COUNTY LINE PLAZA

Comments on the Conditional Use Permit Request by Lee Moore Oil
Public Hearing before the Chatham County Board of Commissioners
18 September 2006
Allison E. Weakley, Biologist

Figure 1. Soils map of proposed County Line Plaza development site on Chatham County/Orange County border. Soil map unit symbols are shown per current Chatham County soils data (USDA-NRCS 2006); see also Appendix 1 for descriptions for soil map units.

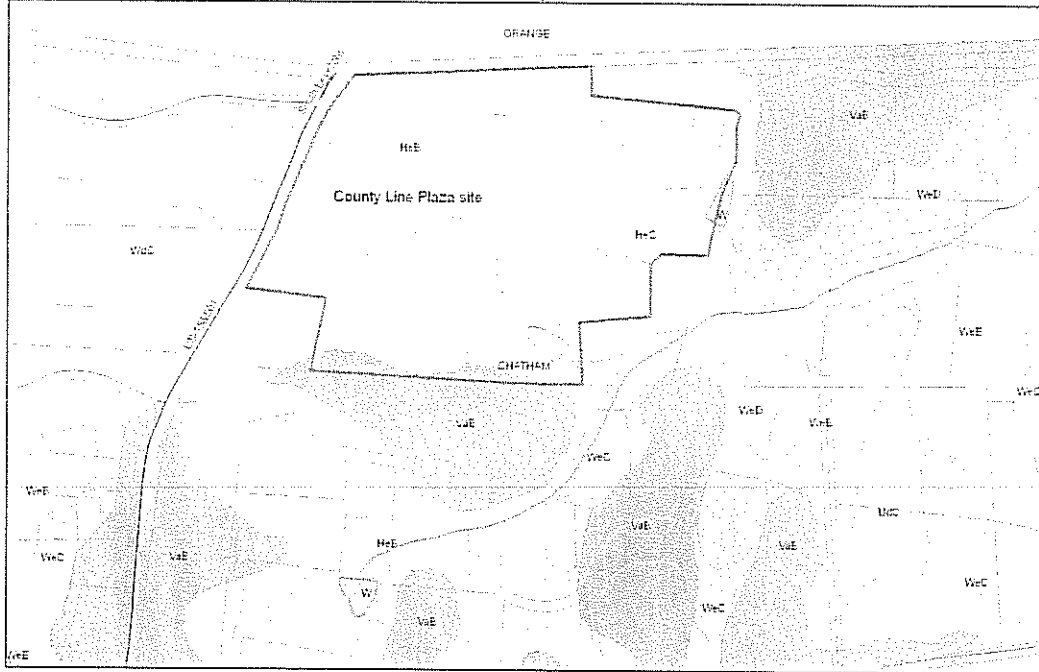
The HeB (Helena) soil map unit is considered to be a "hydric" soil type. Hydric soils are defined by the National Technical Committee for Hydric Soils (NTCHS) as soils that formed under conditions of saturation, flooding, or ponding long enough during the growing season to develop anaerobic conditions in the upper part. These soils, under natural conditions, are either saturated or inundated long enough during the growing season to support the growth and reproduction of hydrophytic vegetation (see attached table with information on Hydric Soils from USDA-NRCS 2006). It's no surprise, then, that the existing ponds found on the Lee Moore Oil site, as well as the stream that drains the site within hydric soil types.

The proposed County Line Plaza shopping center therefore is proposed for an area with significant land area composed of hydric soils.

The County Line Plaza application shows a drip irrigation wastewater system proposed for Helena soils in the northeastern corner of the property. As I just mentioned, Helena soils have "very limited" capacity for sewage disposal via septic absorption. These soils also have a seasonal high water table within depths of 1.5 to 2.5 feet of the surface, and are considered "hydric soils," which are prone to flooding.

The soils data presented in the application show more refined assessment of the soils present on the site, but still show Helena soils in the northeastern corner of the site where more than 8 acres of wastewater drip irrigation are proposed.

Figure 2. Map showing County Line Plaza site draining to, and forming the headwaters of, Wilson Creek within the Morgan Creek watershed.

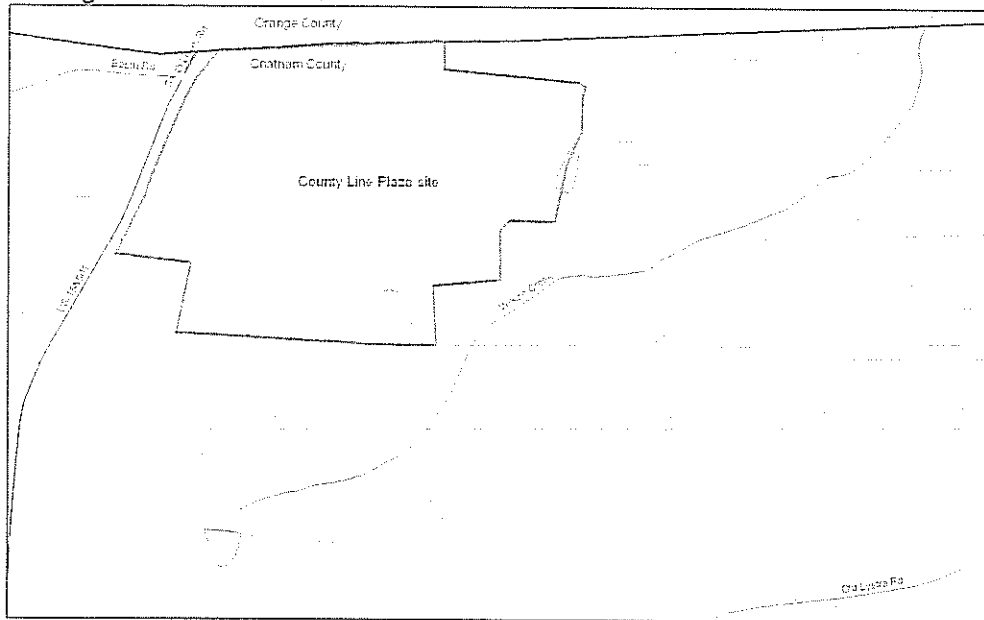
The entire County Line Plaza site drains to, and forms the headwaters of, Wilson Creek (see Figure 2 below).

Wilson Creek drains north to its confluence with Morgan Creek in Orange County, and Morgan Creek then drains to the New Hope Arm of Jordan Lake. Morgan Creek is "impaired" just south of its confluence with Wilson Creek, as is the New Hope Arm of Jordan Lake and the entire Lake itself.
